Re: Update to Zion Road EIS and Impact Assessment 53814 Zion Road, Township of Wainfleet

In 2021, LCA Environmental prepared an EIS to support an application for proposed severance of 53814 Zion Road, in the Township of Wainfleet, to create six rural residential lots. The EIS was scoped to identify potential impacts of development to the Provincially Significant Wetland (PSW) and the woodland feature.

Figure 1: First design alternative considered for 53814 Zion Road, Wainfleet.

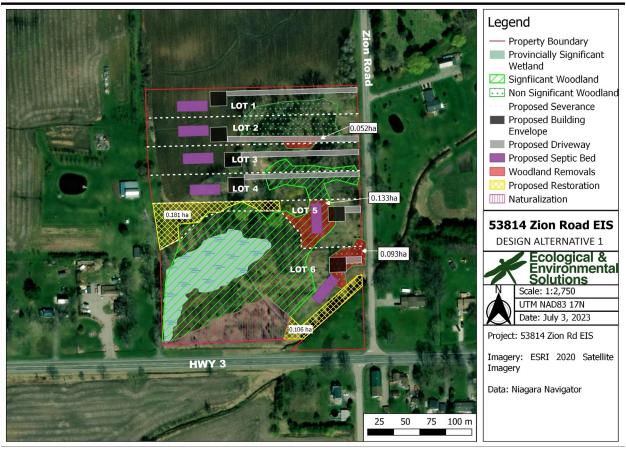
During the site visit on February 17, 2023, Regional staff noted that, for the four northern lots, relocating the proposed dwellings to the west side of the site within the unvegetated areas would limit the need for tree removal and reduce the impacts associated with creating the lot lines through the wooded areas. Town staff also agreed that larger front yard setbacks could be considered for rural residential lots. Consequently, a minimum front yard setback for Lots 1-4 was considered to limit the requirement for tree removal (see Figure 1).

Figure 1 shows the first alternative considered based on the feedback provided by Regional staff during the site visit in February 2023.

The proposed severance for lots 1 through 4 did not change, but the dwellings were relocated to the cleared areas in the west side of the lots to avoid tree removals. The lot line between lots 5 and 6 in this alternative were adjusted to retain 1.245ha of the Significant Woodland within Lot 6.

However, following discussions with Terra-dynamics Consulting, the existing subwatershed divide and presence of a water well immediately west of the property significantly limits the ability to relocate the septic beds for each lot.

Due to the permeability of the soil, the mandatory 30m setback from the well is not sufficient to protect the water well from potential contamination. The recommendation of the hydrogeology study is to maintain the septic beds east of the existing drainage divide on the lot. Consequently, a second design alternative was developed to minimize impacts to trees within the Significant Woodland to the extent possible while also maintaining septic east of the drainage divide (Figure 2).

Figure 3: Final proposed Site Plan for 58314 Zion Road, Wainfleet.

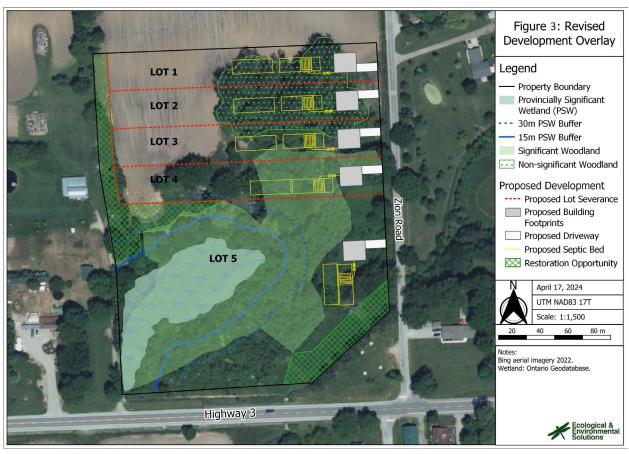
During a meeting held on February 12, 2024 to discuss the revisions to the site plan, the Township, the Region, and the NPCA indicated that their preference was to protect the natural features within a proposed residential lot. The Region of Niagara also expressed continued concern with the impacts to the Significant Woodland by maintaining Lots 4 and 5 as two separate building lots. A third design alternative for 5 building lots was negotiated, in which Lots 4 and 5 were combined to include the PSW and Significant Woodland feature.

The final site plan, established through discussions with the Region of Niagara, NPCA, and Township of Wainfleet, proposes five rural residential lots, through severance. The proposed severance will result in four lots (Lots 1- 4) located north of the PSW and Significant Woodland, and one lot (Lot 5) which includes a proposed building and septic footprint, the PSW and associated setbacks, as well as the Significant Woodland feature to be preserved (Figure 3).

The footprints for future dwellings and septic design are located east of the subwatershed divide to protect the neighbouring private well system. The proposed lot line for Lot 5 extends north along the western property boundary to maintain connectivity to the hedgerow which extends north through the adjacent agricultural lands and provides a direct linkage to other woodland and wetland communities.

Previous design alternatives proposed lot lines which abutted or extended along the minimum recommended 15m setback from the PSW. However, the final site plan protects an increased setback, with a minimum 25m from the adjacent lot (Lot 4), but mainly exceeding 30m.

Opportunities for enhancement of native vegetation and/or ecological function have been identified in Figure 3. In the northwest part of Lot 5, native tree/shrub planting will increase woodland canopy cover while also improving the function of both the wetland buffer, and north-south hedgerow corridor. Additional plantings along the north bank of the Ellsworth drain will also enhance buffer function, protecting water quality from runoff associated with future residential use.
